From: [REDACTED]
Sent: 20 July 2016 08:40
To: [REDACTED]
Cc: MS Marine Renewables; [REDACTED]
Subject: RE: ONE WEEK REMINDER Consultation on BOWL Post-consent Development Specification and Layout Plan, Offshore Transmission Works (DSLPP-OfTW), by 26th July

BEATRICE OFFSHORE WIND FARM

SNH & JNCC COMMENTS ON CABLE PLAN

National Coastal Change Assessment: Interim result for cable landfall on Spey Bay (Moray).

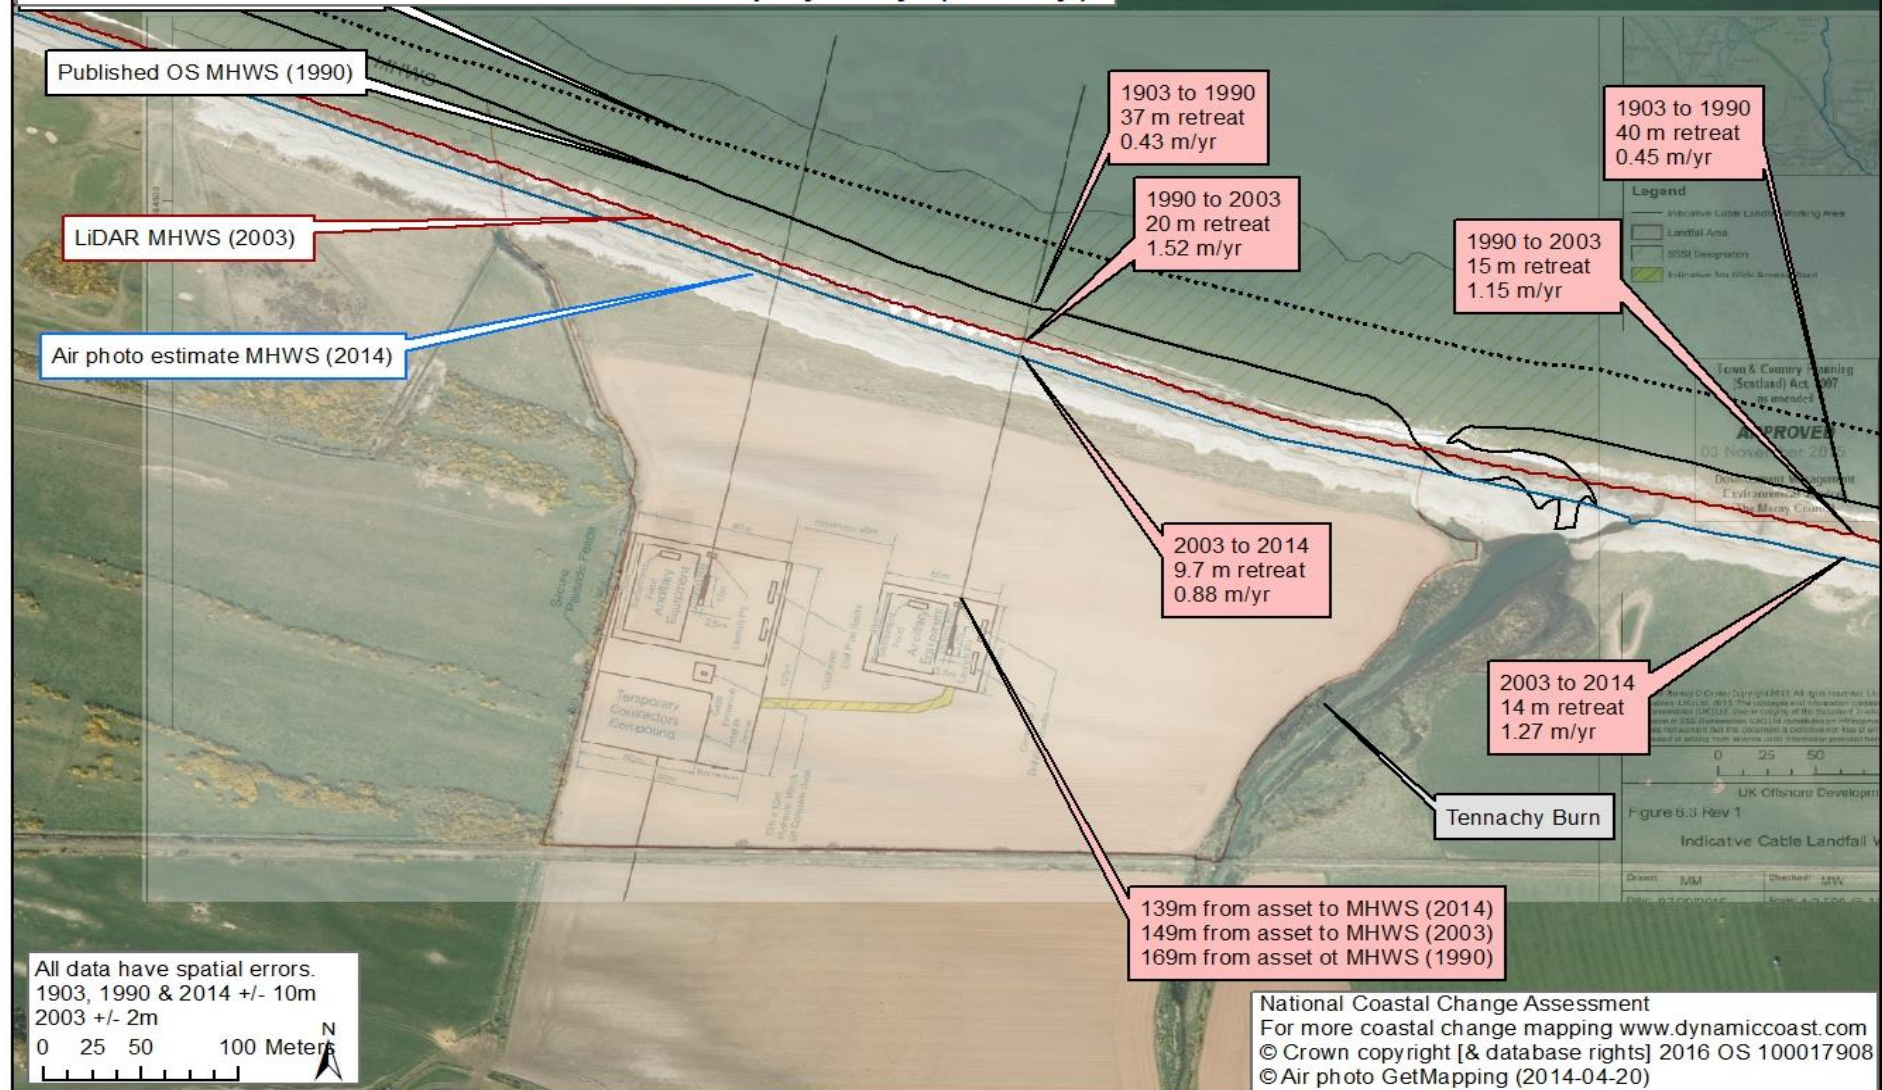
Further to discussion at the meeting of 31 May 2016, and subsequent emails, we are able to provide the following advice on coastal erosion in Spey Bay SSSI. Please see **Appendix C** for a map illustrating the line of MHWS recorded at different points over time. This information is taken from the ongoing National Coastal Change Assessment: <http://www.dynamiccoast.com/>

The map indicates different rates of erosion – between 0.43 and 1.52 m per year – relating to the three points in time at which the position of the coastline has been measured. The data is sparse and it doesn't suggest any long-term trend (e.g. stable, accelerating or slowing); the associated error margins are also large (e.g. rates could be halved or doubled). So while it is difficult to define a "representative" rate of erosion, the available information does indicate that this has generally been over 0.5m per year and that for significant periods of time it has exceeded 1m per year, occasionally coming close to 2m per year.

- There is an absence of any source of 'new' gravels to feed the beach at this east end. This makes persistent erosion more likely, contrasting with other areas of Spey Bay where there may be cyclic variation between periods of erosion and periods of stability or growth.
- Changes to gravel landforms around the mouth of the Spey are less likely to influence this end of the beach as the longshore movement is dominantly to the north-west.
- Any unsteadiness in erosion resulting from periodic growth of gravels across the Tennachy Burn is likely to be very minor especially in comparison to storm-driven variations.
- Erosion over the past century has been eating into the old, vegetated gravel ridges located in this area, and this is likely to continue despite the rising slope of land.

Taken together, these considerations give no reason to think that long-term erosion rates will significantly reduce in future. Infrastructure should therefore be planned to allow for an eroding coastline.
